In the Matter of
Carolina Power and Light Company and
North Carolina Eastern Municipal Power Agency
(Shearon Harris Nuclear Power Plant, Units 1 and 2)
Docket Nos. 50-400-OL and 50-401-OL

SUBJECT: SAFETY EVALUATION REPORT, TRANSAMERICA DELAVAL, INC.
DIESEL GENERATOR OWNERS GROUP PROGRAM PLAN

SAFETY EVALUATION REPORT
TRANSAMERICA DELAVAL, INC.
DIESEL GENERATOR OWNERS GROUP PROGRAM PLAN

REVIEW AND EVALUATION
OF TDI DIESEL GENERATOR
OWNERS' GROUP PROGRAM PLAN

FIGURE 1. Approach for Establishing Diesel Engine Reliability/Operability

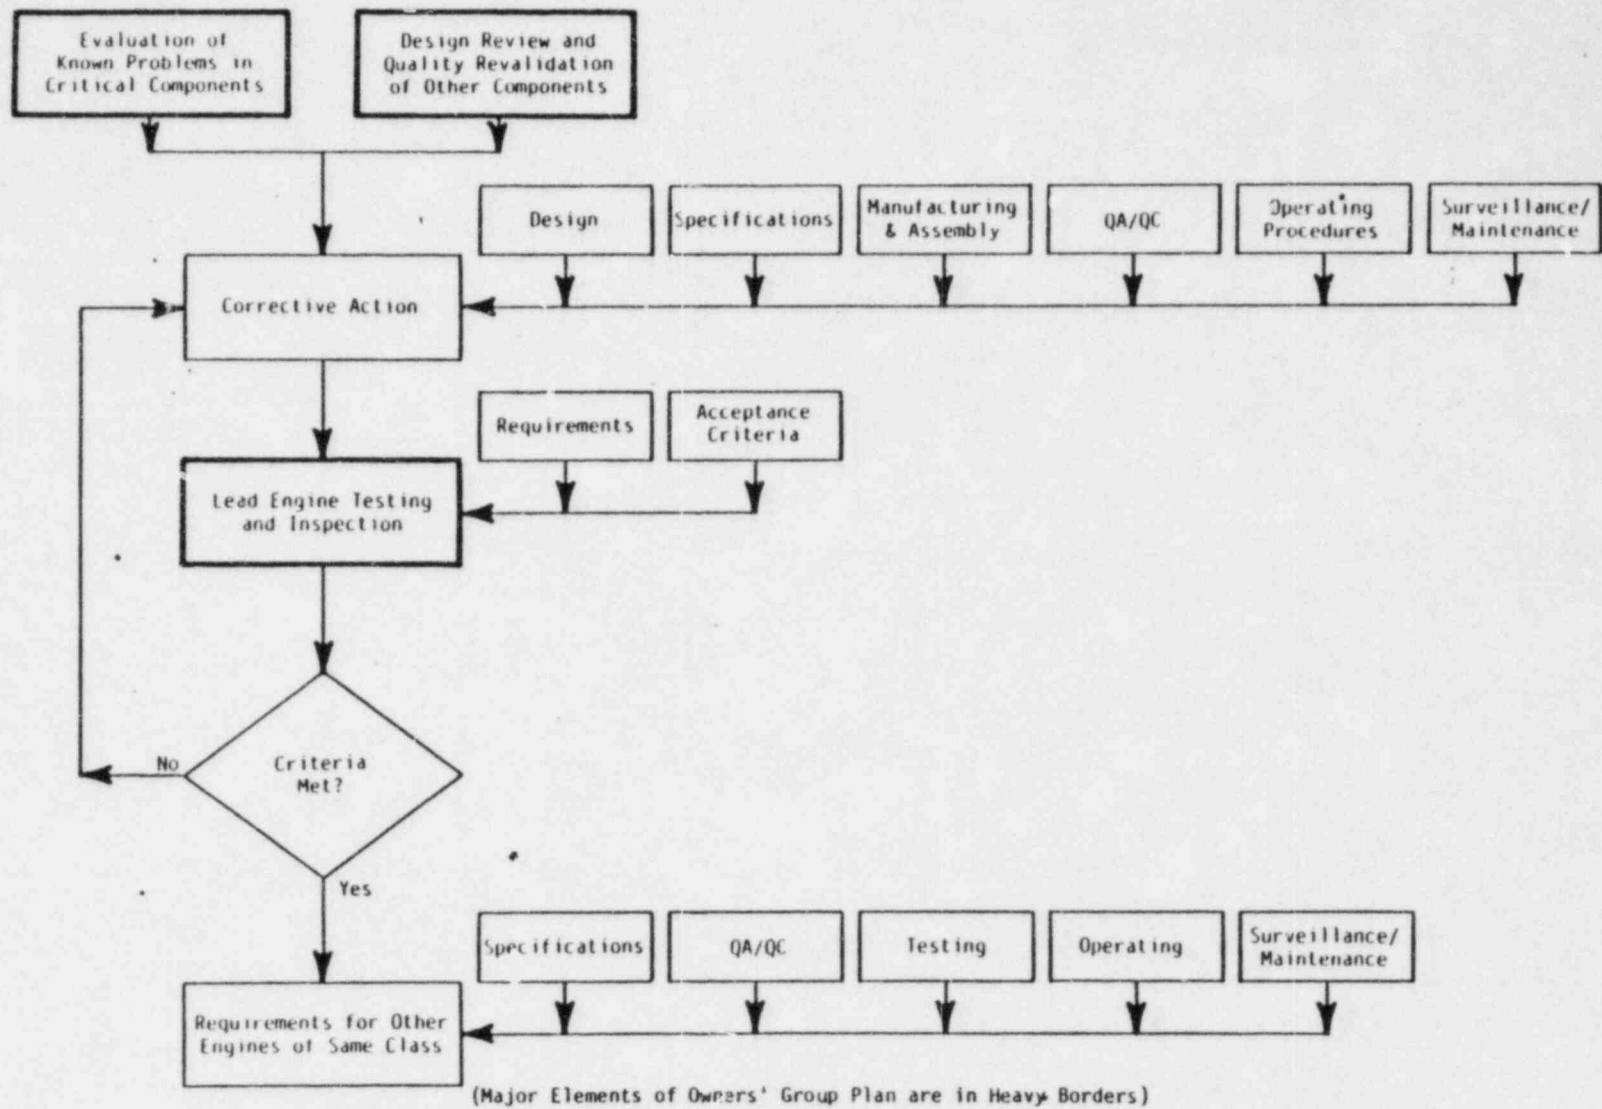
These three elements are illustrated schematically in Figure 1 as part of an overall approach for establishing diesel engine operability and reliability. Included in Figure 1 are factors that warrant attention, according to PNL's consultants, in the action planned to correct deficiencies, verify the adequacy of the corrective action, and apply the lessons learned to all engines of the same class. Many of these factors are included explicitly or implicitly in the Owners' Group Program Plan. These factors and related issues identified in PNL's review of the Plan are discussed under the five subheadings that follow:

- identification of root cause(s)
- corrective action - As illustrated in Figure 1, factors that should be considered as appropriate include design, specifications, manufacturing and assembly, quality control/quality assurance, operating procedures, and surveillance and maintenance.

The program logic of Figure 1 forms a basis for identifying the critical elements needed to establish TDI engine operability and reliability for nuclear service (i.e., program elements that should be accomplished prior to licensing action). The evaluation of the Owners' Group Plan in Section 2.0 reflects these elements, which are:
